UNITED STATES
DEPARTMENT OF THE INTERIOR
BUREAU OF LAND MANAGEMENT

SUNDRY NOTICES AND REPORTS ON WELLS
Do not use this form for proposals to drill or to re-enter an abandoned well. Use form 3160-3 (APD) for such proposals.

NEDU 242 Proposed Workover Procedure

Conditions of Approval

WELL DIAGRAM (PROPOSED CONFIGURATION)

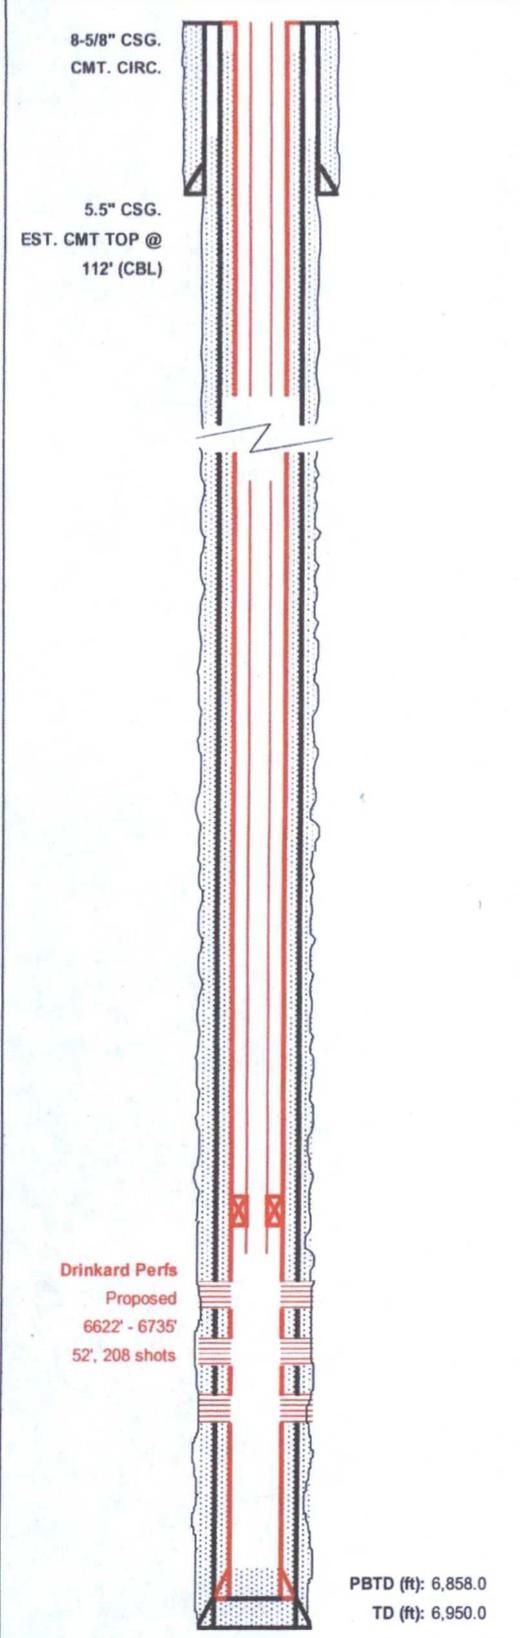
8. A 4", 9.5 lb/ft, J-55, liner with TMK UP Ultra FL coupling is approved for installation. Operator's installed liner must have mechanical specifications as good or better as that approved.

9. After setting the liner and before perforating, **perform a charted casing integrity test of 800psig minimum.** Document the pressure test on a one hour full rotation calibrated (within 6 months) recorder chart registering within 35 to 75 per cent of its full range. **Verify all annular casing vents are plumbed to the surface and open during this pressure test.** Include a copy of the chart in the subsequent sundry for this workover.

11. Provide BLM with an electronic copy of the 4" liner cement bond log record from 6800 or below to top of cement taken with 0psig casing pressure. The CBL may be attached to a pswartz@blm.gov email.
